802.3dj D3.0

Comment Resolution

Electrical Topics

Vf (Preset 1) –vs- Rpeak

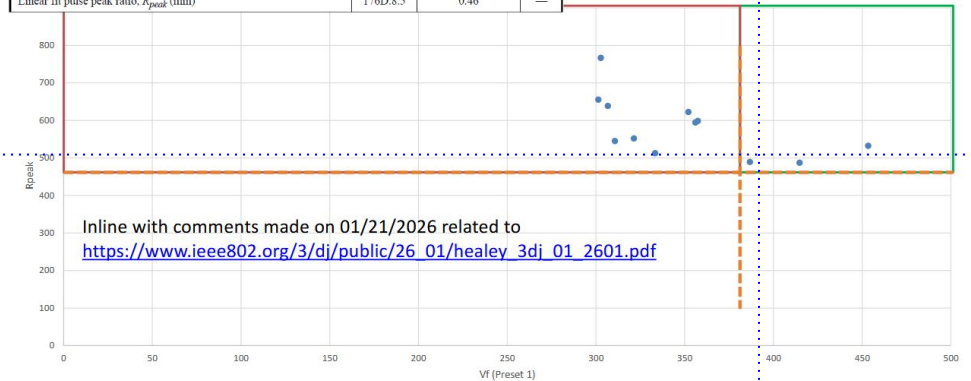
Vf minimum value of .389V still fails the majority of early designs.

The interop report out:
https://www.ieee802.org/3/dj/public/26_01/calvin_3dj_01a_2601.pdf Page 23 shows 9 out of 12 modules failing Vf. We either need to review the measurement methodology in Vf (which is not new) or consider further reduction of the Vf values to 350mV.

Referenced presentation is [calvin_3dj_01a_2601](#).
 Slide 23 (below) shows *module* output parameters.

Blue dotted overlay lines show (approximately) the new limit values proposed by comment #175.

PROPOSED REJECT.
 The v_f specification is an important component of the COM analysis that supports the loss budget of 32 dB for C2M applications. Reducing the minimum v_f would undermine this analysis and prevent interoperability with worst-case hosts.
 The information in the referenced presentation does not justify reducing the v_f limits. It shows that some of the tested modules met the requirements. Devices that failed the requirements might have not been configured correctly or might be non-compliant.
 [Editor's note: changed clause/subclause/page from 179D/179D.6.3/821 to 176D/176D.6.5/822]

Figure 179B-3—Mated test fixtures common-mode to differential-mode insertion loss requirements

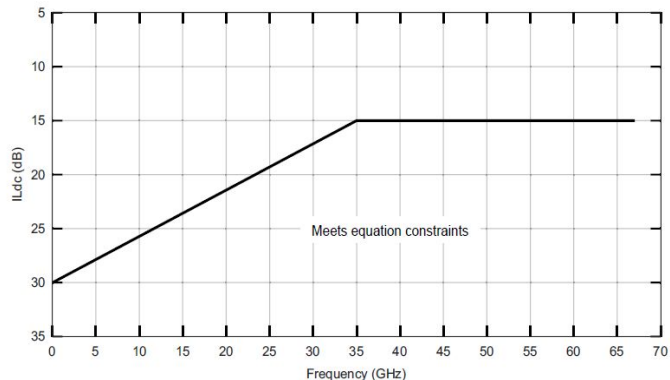
Intrapair skew has not been directly considered for the MTF. Although intrapair skew is included in the computed differential mode to differential mode insertion loss, the effect of skew has not been explicitly specified. Common mode to differential mode insertion loss does contain elements of skew. An either or specification for SCMR_CH should be added to control MTF intrapair skew.

The common-mode to differential-mode insertion loss of the mated test fixtures measured in both directions shall meet Equation (179B-6) as illustrated in Figure 179B-3. or the channel signal to common-mode ratio (SCMR_CH) shall exceed 12 dB using the procedure described in 179.11.7.

The comment suggests adding a minimum SCMR_CH of 12 dB as an alternative to the frequency mask of Equation 179B-6.

SCMR_CH is a specification of cable assemblies. The specifications of test fixtures cannot rely on the cable assemblies they are used to measure.

Note also that the mated test fixture includes an HCB which has no other specification of mismatch.

The text of the suggested remedy is unclear.

The minimum SCMR_CH specification of cable assemblies is 12 dB, and it seems that the mated test fixtures should be significantly better than that (cable assembly measurement includes two MCBs).

Replace line 3 with:

"The mated test fixture shall comply with at least one of the following conditions:

- The common-mode to differential-mode insertion loss of the mated test fixtures measured in both directions meets Equation (179B-6) as illustrated in Figure 179B-3.
- The channel signal to common-mode ratio (SCMR_CH) is greater than <x> dB using the procedure described in 179.11.7."
